Rezoning Transportation Analysis

Petition Number: 2021-174

Rezoning Transportation Analysis

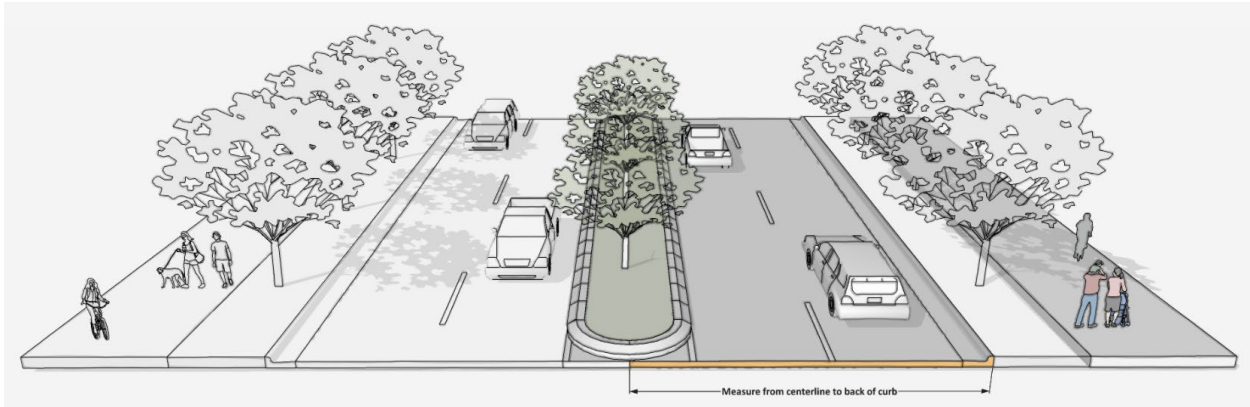
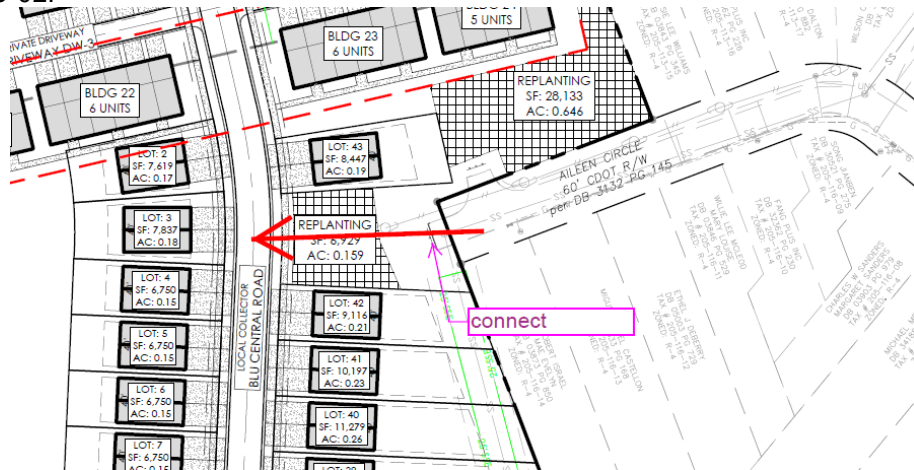
Curbline: The proposed zoning district has a setback measured from back of the future curbline.

- ~~**East Westinghouse Boulevard:** The future back of curb and gutter shall be installed at 33 feet from the existing street centerline. Revise site plan to show the future back of curb.~~

Label and dimension the existing and future curb and gutter from the centerline for each road on the site plan.
